## Shelbourne Header - John Deere S7 And X9 Hydraulic Loom

Issue	Date	Changes
1	05/06/2025	Technical service bulletin created

## Hydraulic Looms 293858 01 And 293857 01

**1. Check you have the right fuse.**

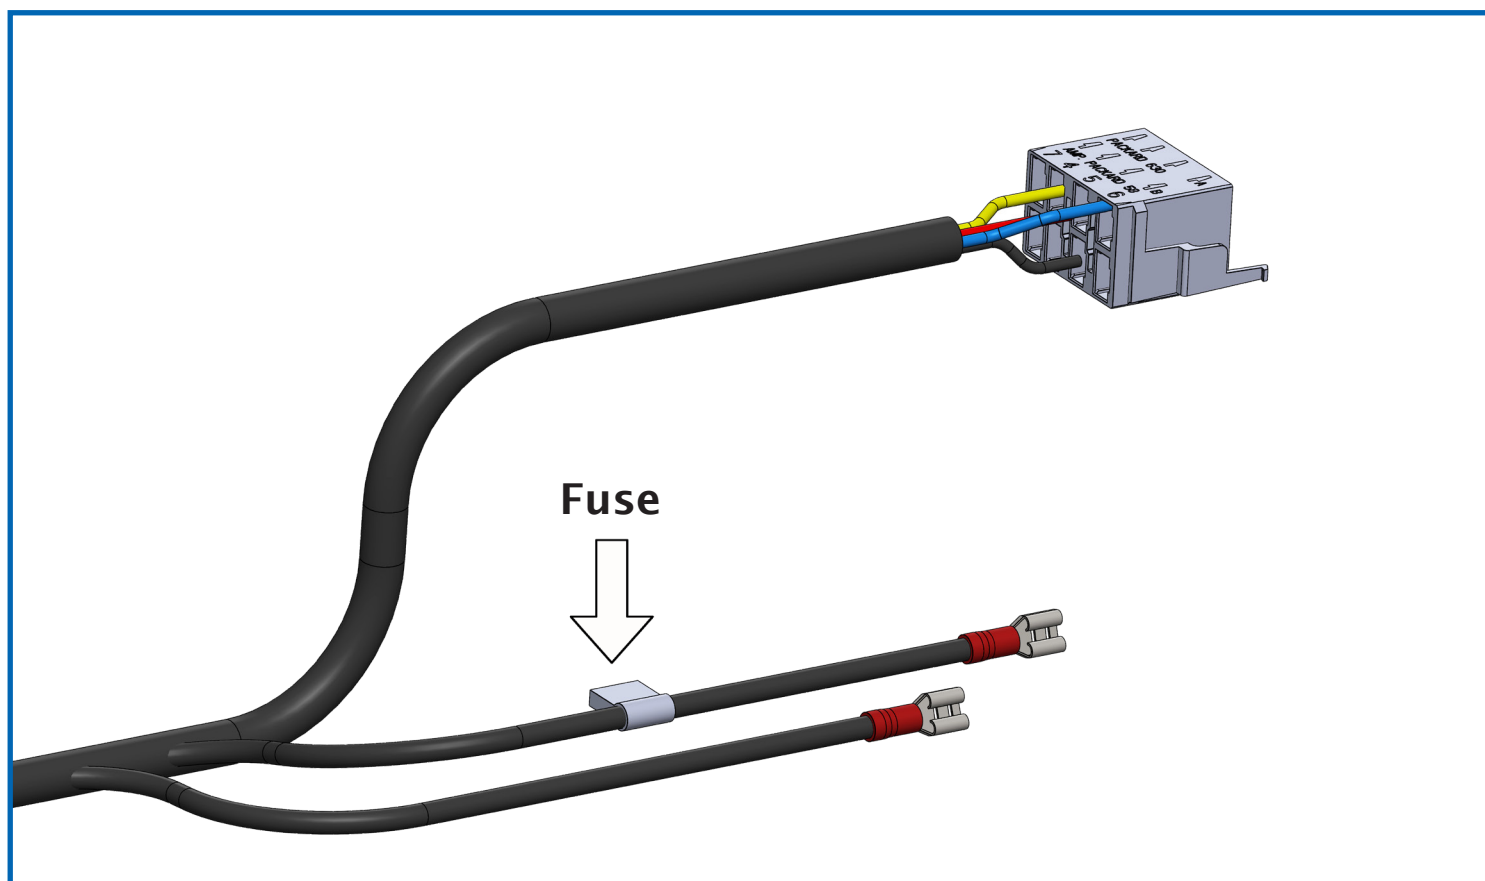
Check the size of your fuse, if it is a 2A fuse it will need to be changed for a 5A one.

### 2. Check if your loom has a fault.

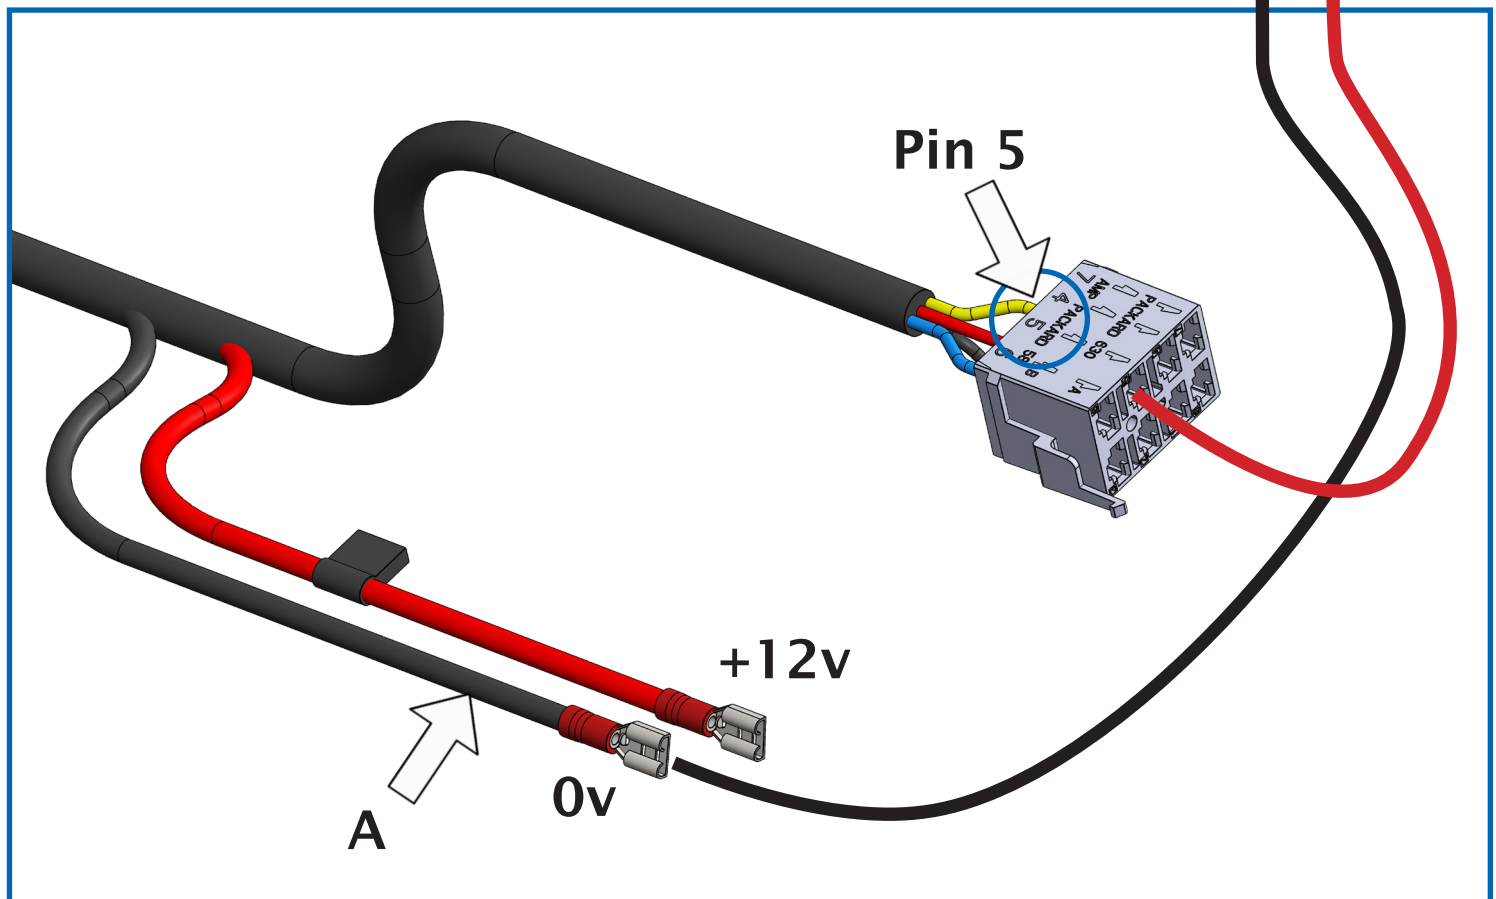
2. Attach the black multimeter probe to the black female spade (0v, not fused) (A), as shown below.

3. Attach the red multimeter probe to pin 5 (switch).

If faulty the multimeter will give you a reading between 500 and 600. The loom will need to be replaced.

If you don't get a reading between 500 and 600 then the loom is correct.
